ATTACHMENT C

**REVISED TSUP PAGES FOR
DRESDEN AND QUAD CITIES NUCLEAR POWER STATIONS
LICENSE NOS. DPR-19, DPR-25, DPR-29, AND DPR-30**

FIGURE 5.1.B-1

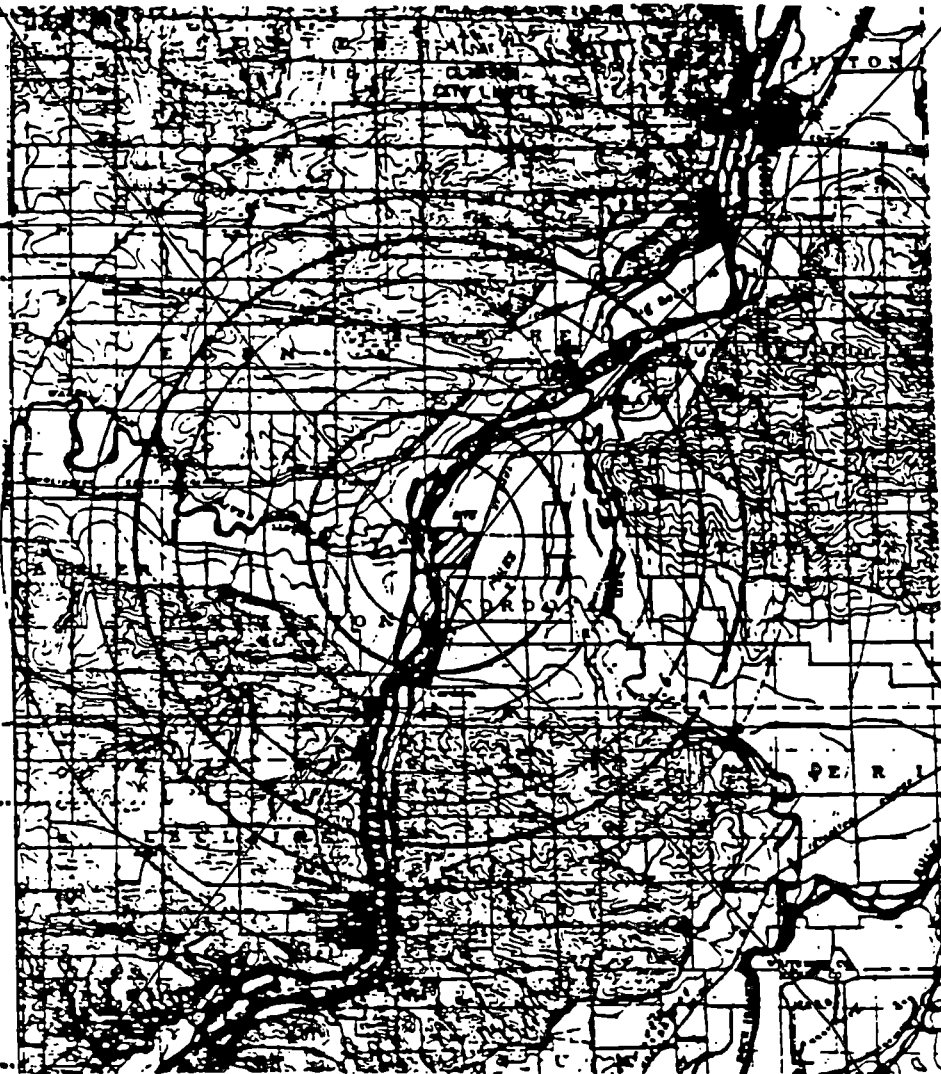
5.1.B The low population zone shall be as shown in Figure 5.1.B-1.

a three mile radius
from the centerline
of the chimney.

INSERT
